The submission references are 2016/6369/P and 2016/6756/L, and they both relate to work proposed to a Listed Building at 150 Highgate Road.

**OBJECTION TO PLANNING SUBMISSION FOR
150 GROVE END HOUSE HIGHGATE ROAD NW5**

Comments on Planning Submission 2016/6369/P

Figure 3. West East section through Grove End House and the gardens of Chetwynd Villas showing the impact of the proposed changes.

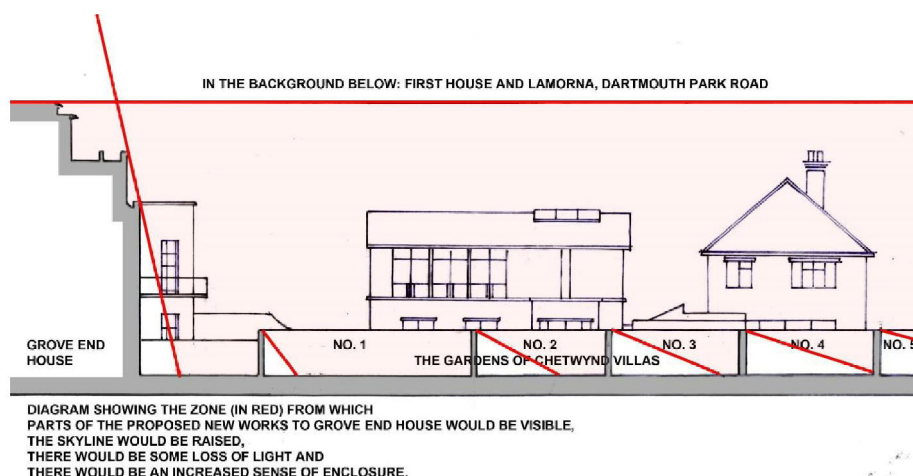
Any increase in the scale of Grove End House would have a further detrimental effect on the neighbouring properties. The section through Grove End House and the gardens of Chetwynd Villas below shows an area, in red, from any part of which the proposed new additions would be visible, the skyline would be raised and there would therefore be some loss of light and an increased sense of enclosure. It would be mainly the view from the gardens of 1 to 5 Chetwynd Villas that would be affected, but as can be seen from the CGI showing the view from the terrace of First House, Dartmouth Park Road, the view south from First House and its garden and from Lamorna would also be seriously affected.
